ADDENDUM NO. 1

RE: HIGH SCHOOL #13

Howard County Public School System

Bid Number: 016.20.B4

dwg
ADD_1_M3

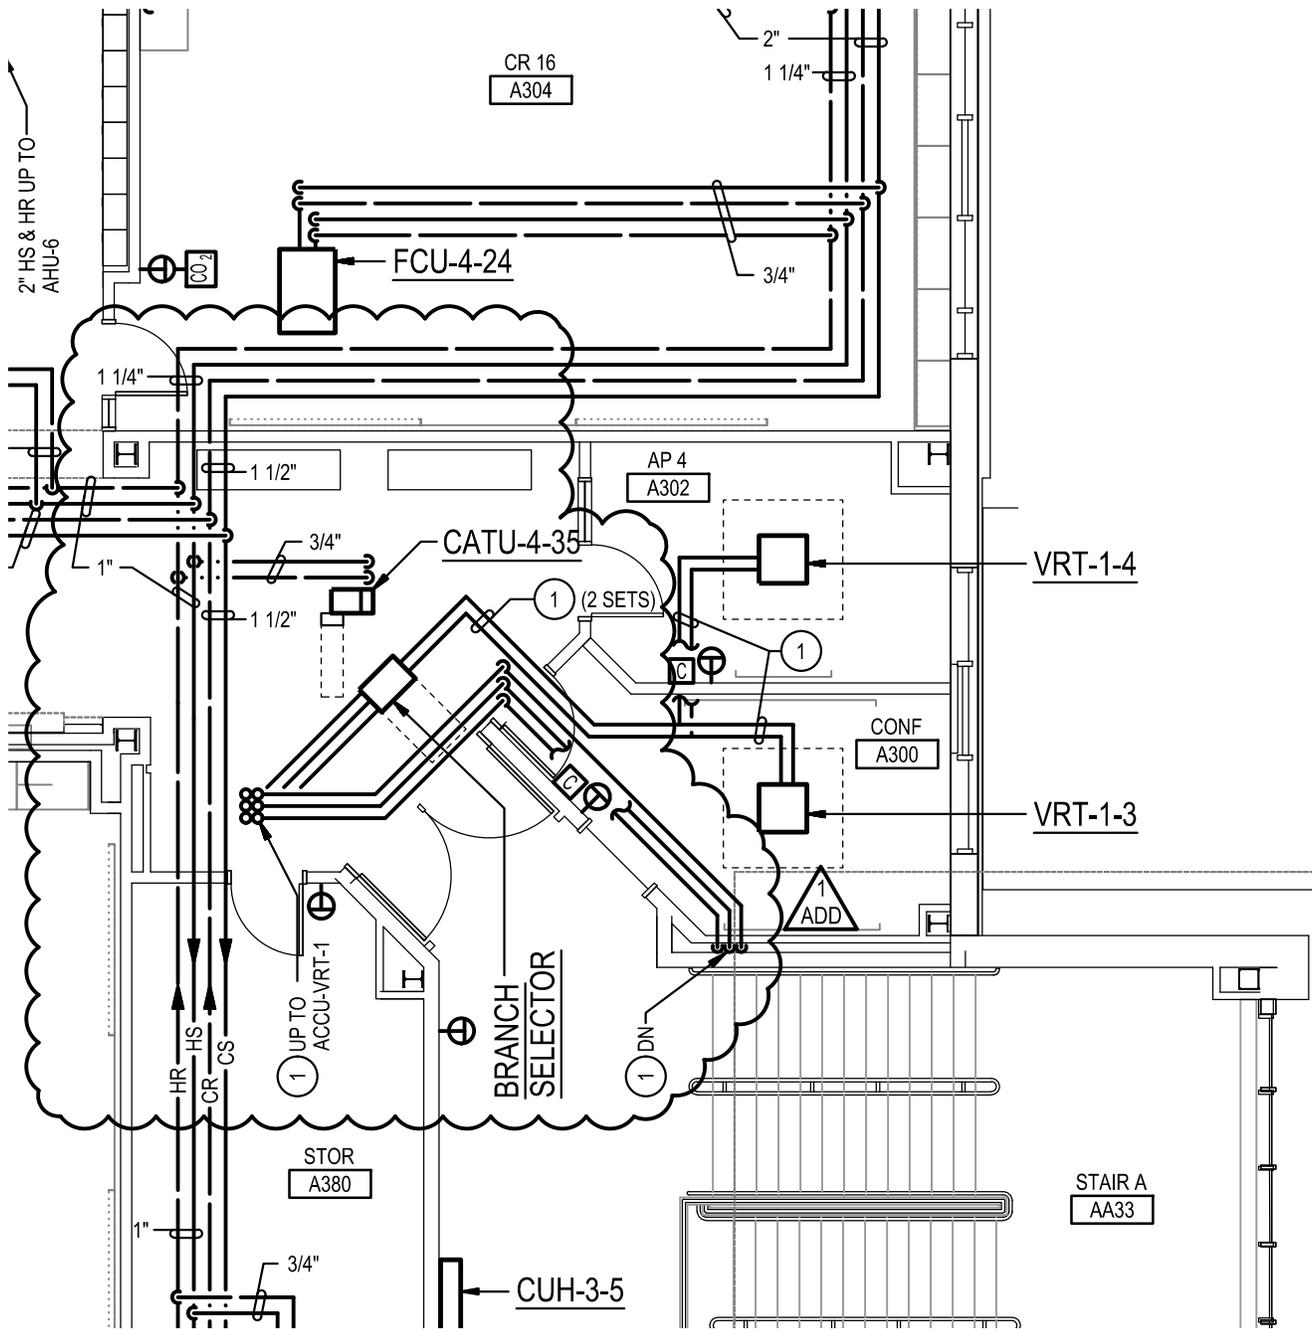
REVISE Piping serving unit in Sculpt-Kiln per sketch ADD_I_M3.

dwg
 ADD_1_M4

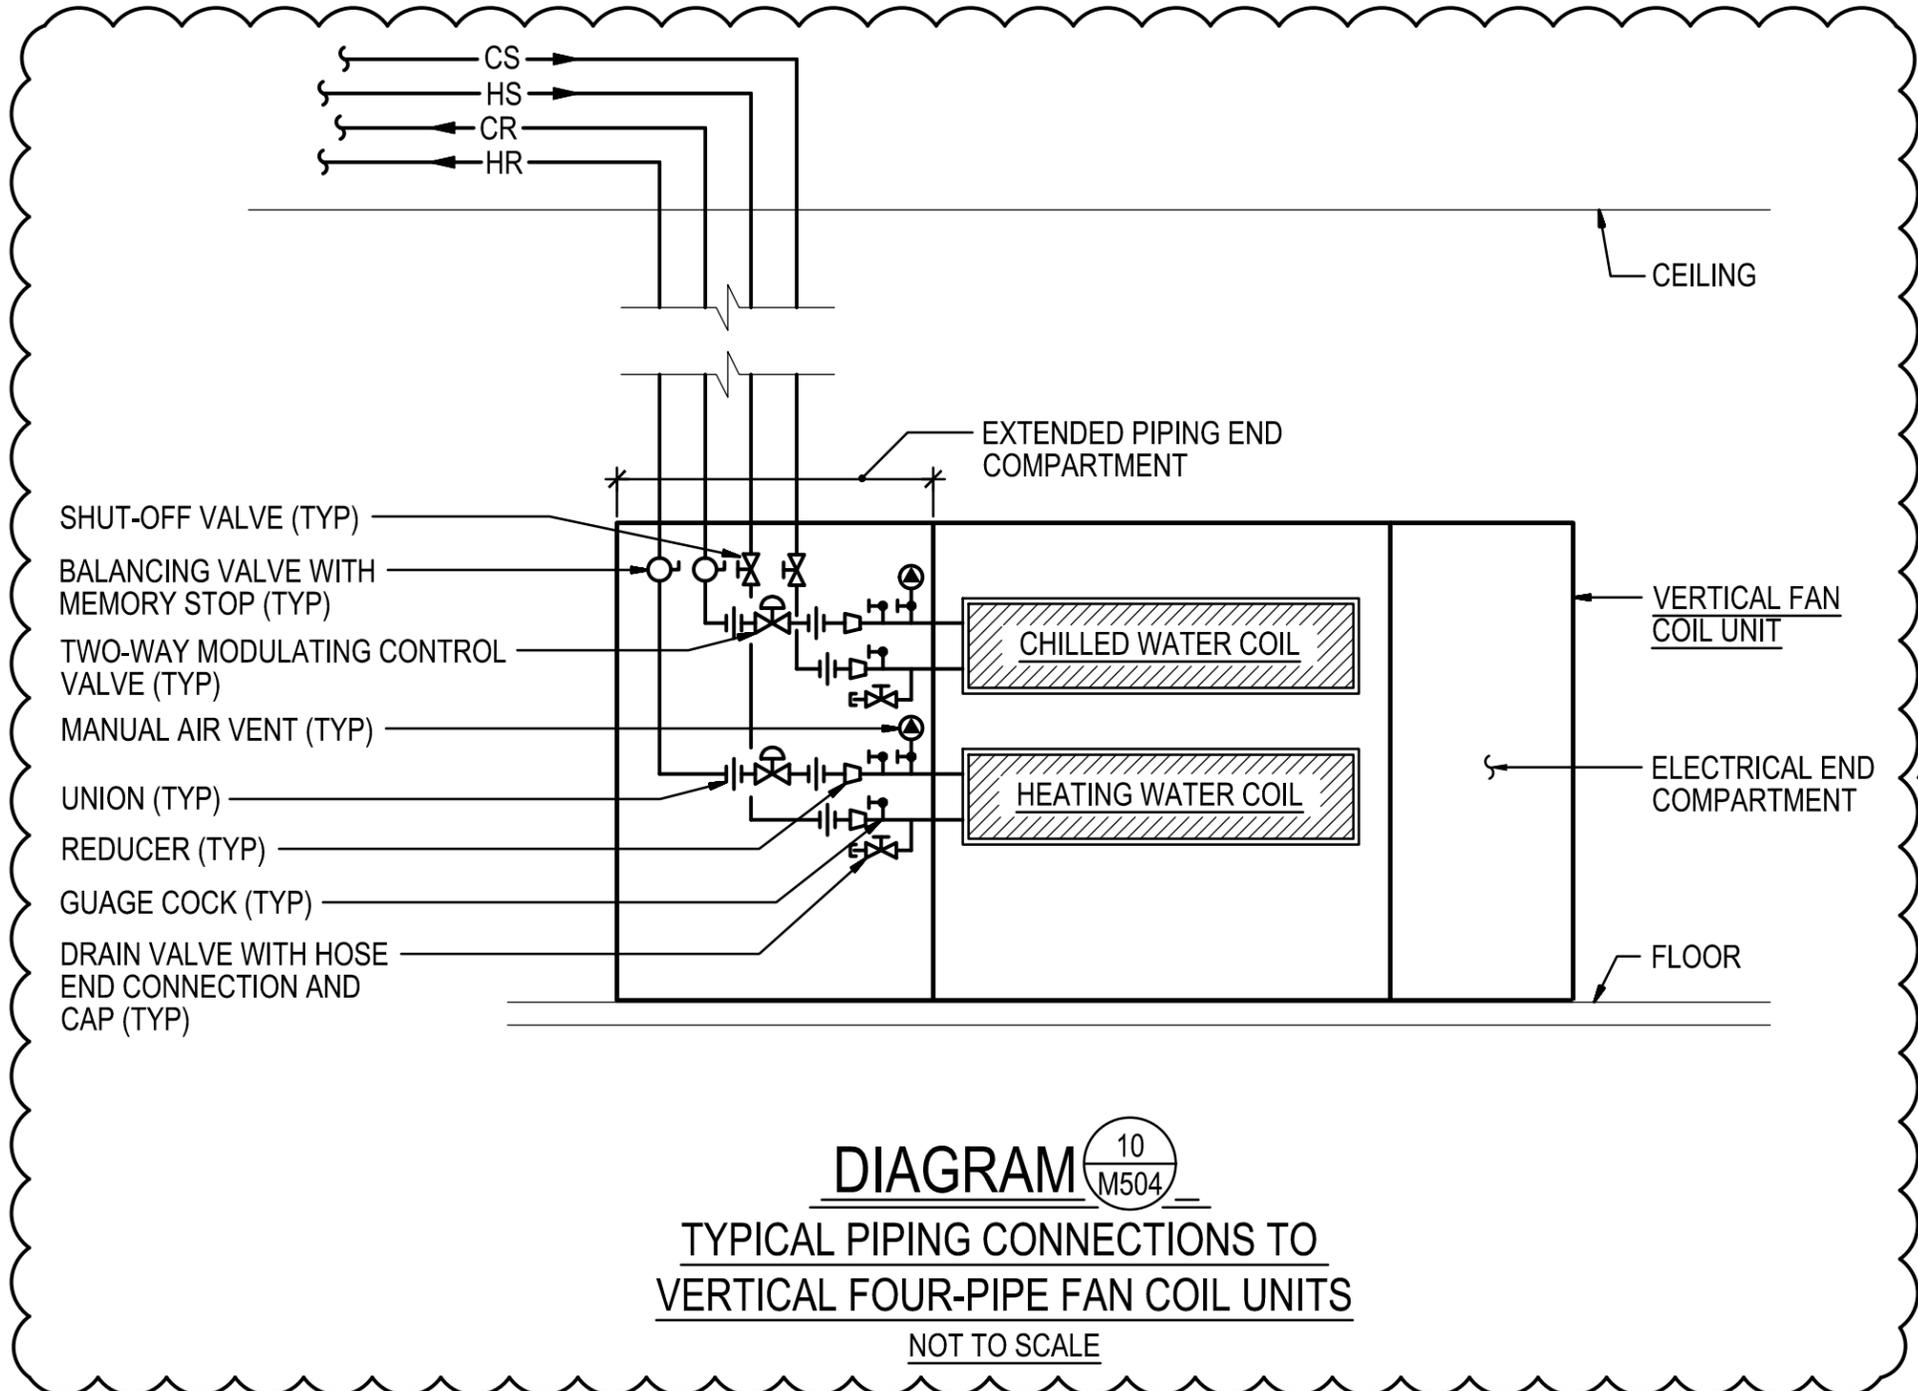
REVISE Refrigerant piping per sketch ADD_I_M4.

dwg
 ADD_1 P1

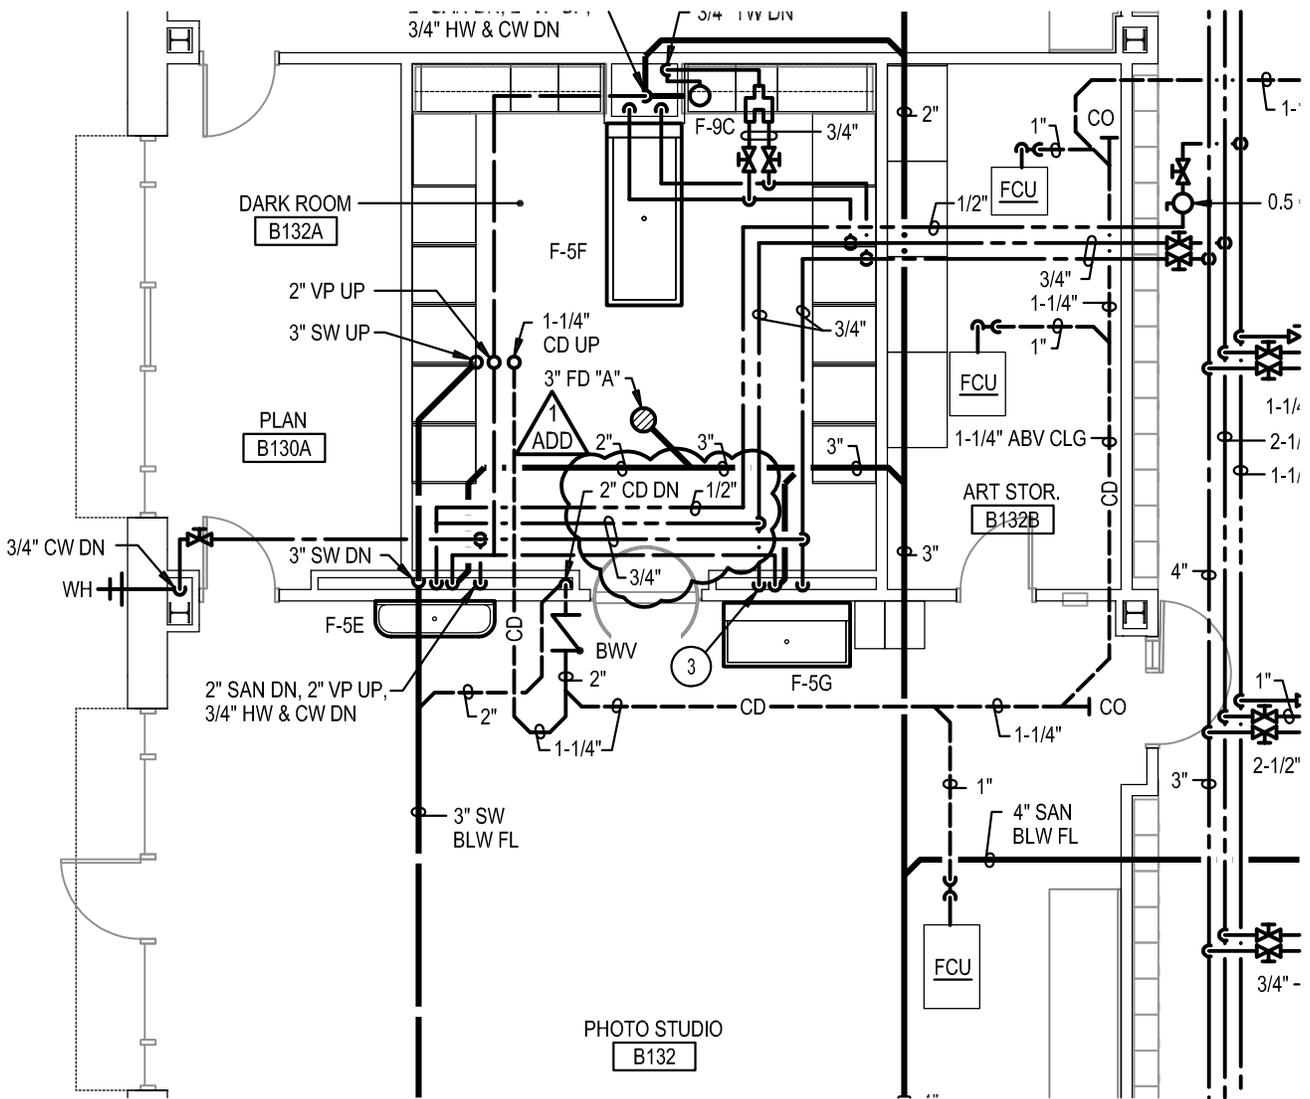
ADD Condensate piping for fan coil unit and revise pipe size per sketch ADD_I_P1.

dwg
ADD_1 P2

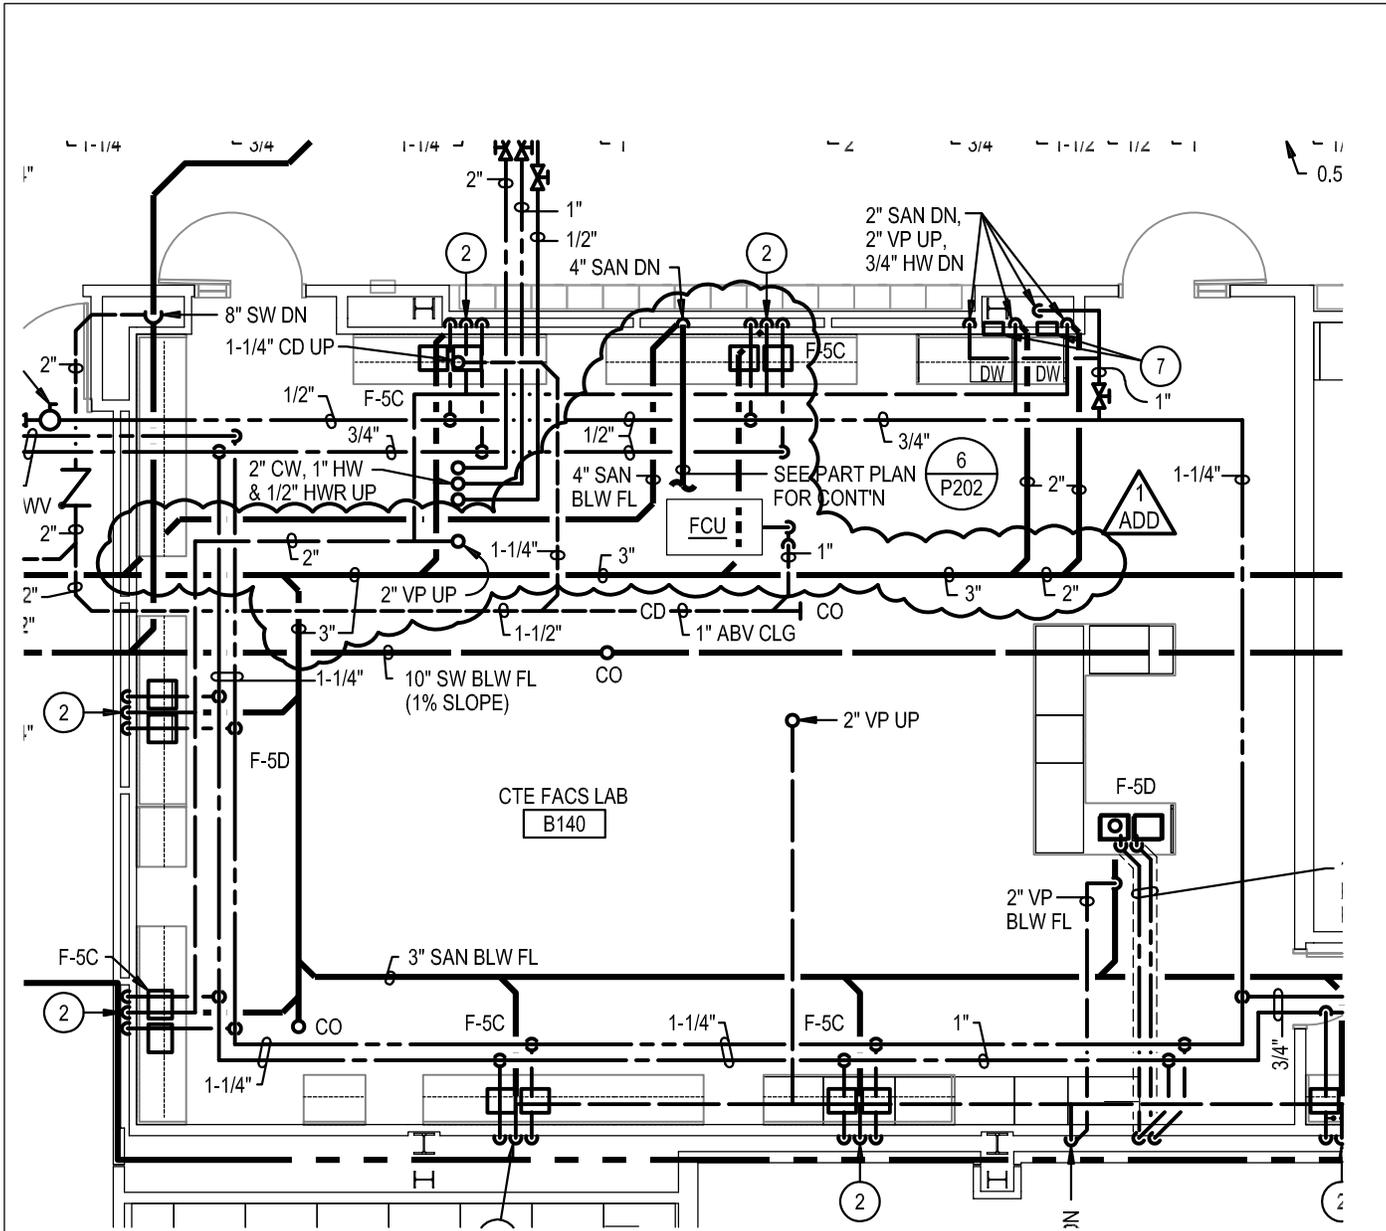
REVISE Pipe size per sketch ADD_I_P2.

dwg
ADD_1 P3

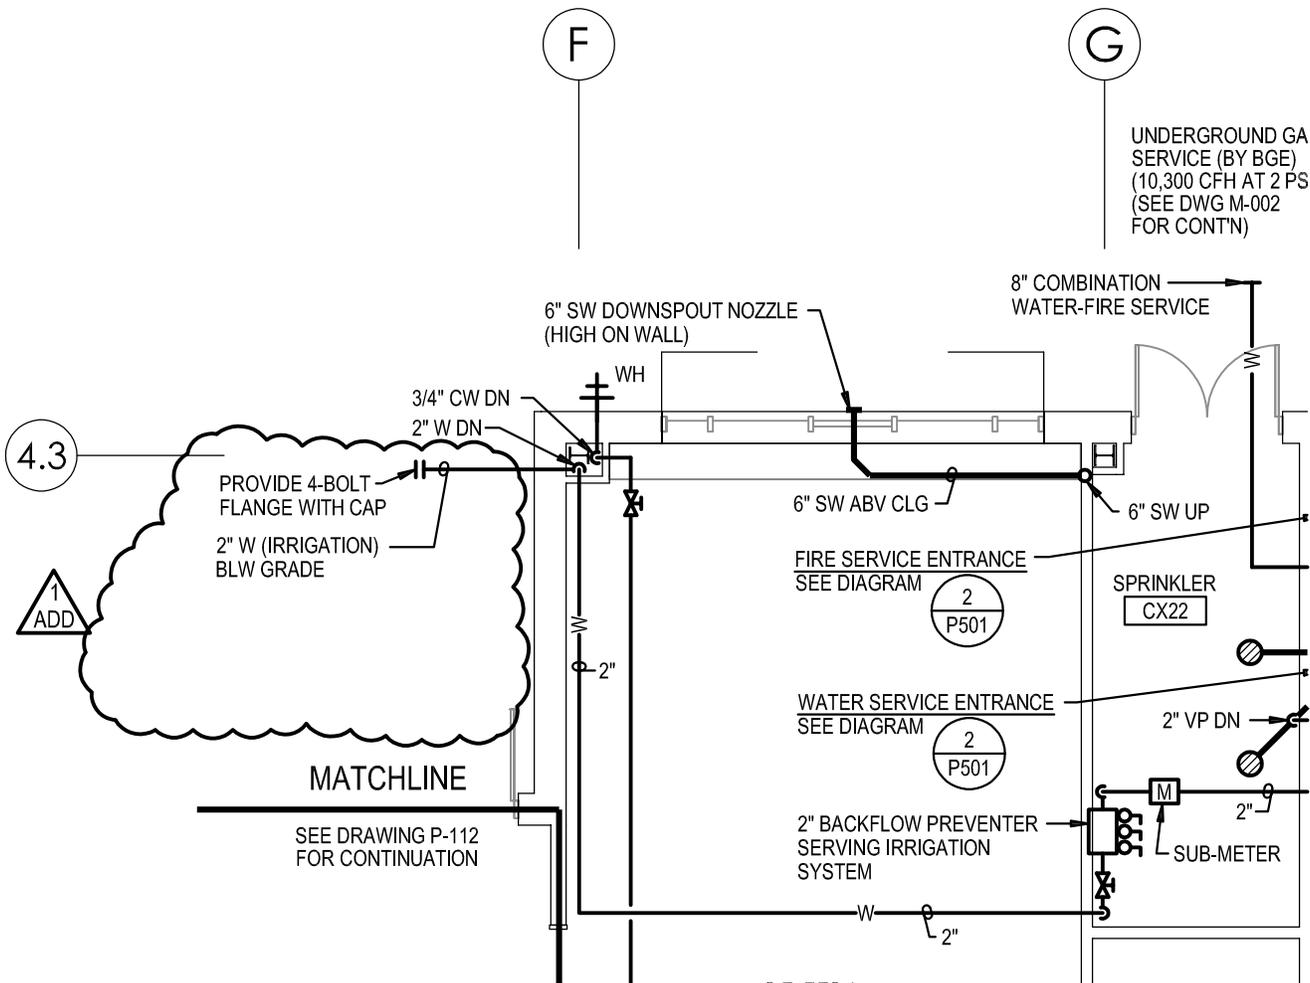
REVISE Sanitary piping per sketch ADD_I_P3.

dwg
ADD_1 P4

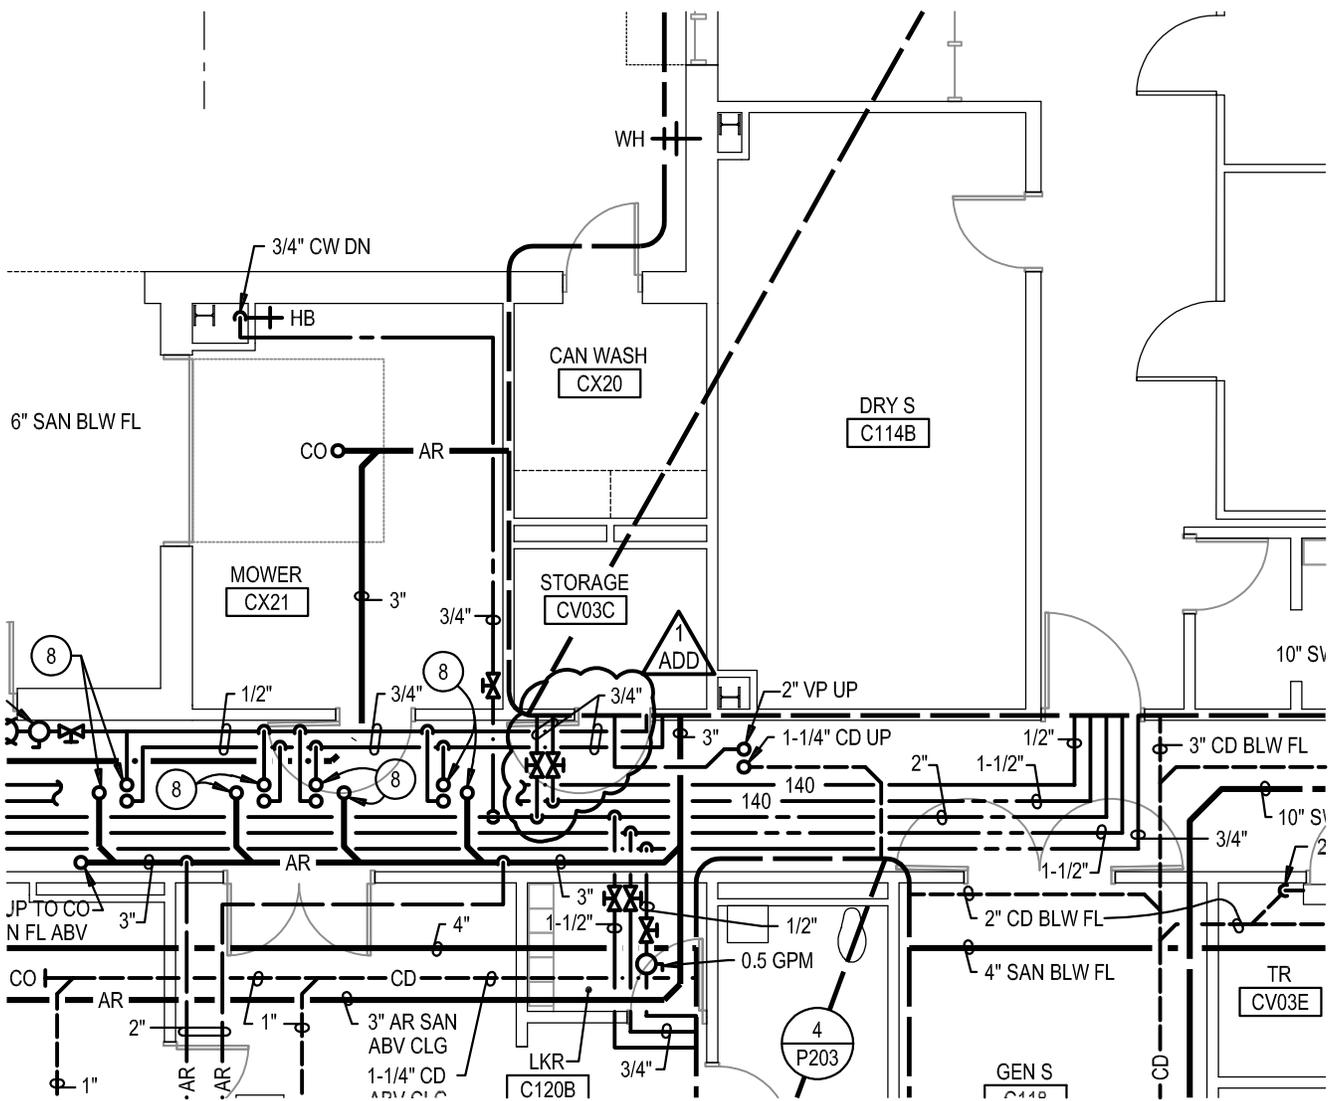
REVISE Irrigation piping per sketch ADD_I_P4.
